PARTY'S NAME	S.P. FABRICATORS PVT. LTD., NAVI MUMBAI
PARTY'S DRAWING No.	AL–422
ALLOY & TEMPER	6063 T6
DESCRIPTION	CURTAIN WALL SECTION–BEADING

DRAWING No.	SECTION No.
P–7762	–
29083	29083–ISSUE–2

MATCHING SECTION

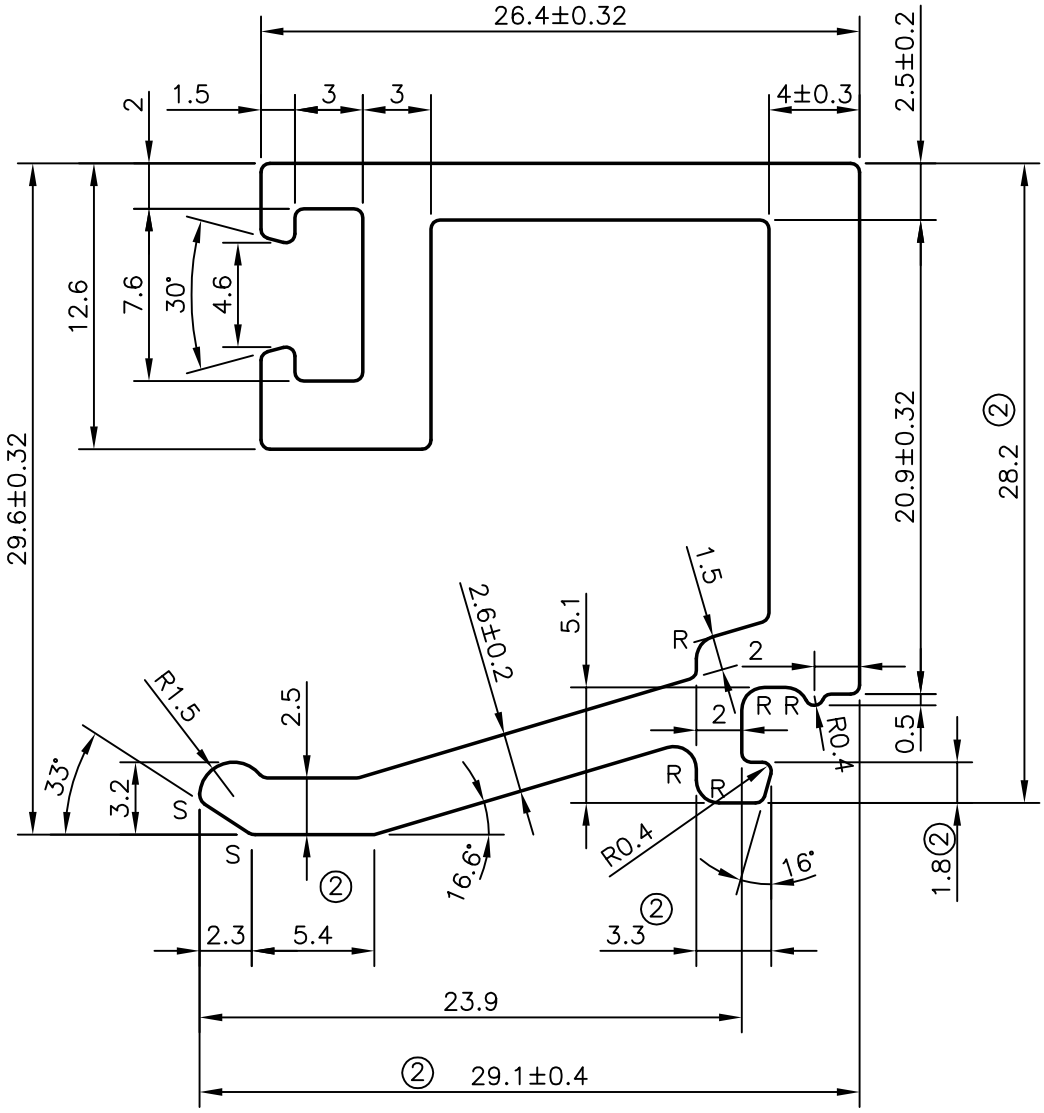
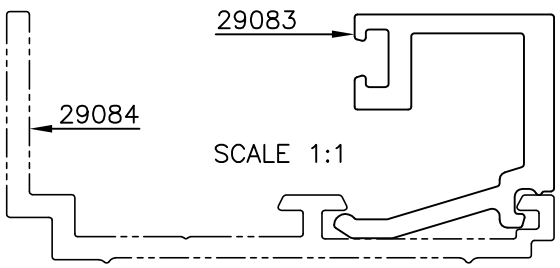
ISSUE – ②
DIMENSIONS REDUSED FROM
30.4 mm TO 29.1 mm, 28.4 mm TO
28.2 mm, 6.7 mm TO 5.4 mm &
3.7 mm TO 3.3 mm
DIMENSIONS INCREASED FROM
1.30 mm TO 1.80 mm, 3.7 TO 4.0 &
7.20 mm TO 7.60 mm &
WEIGHT ALSO CHANGED FROM
0.749 kg/m TO 0.738 kg/m
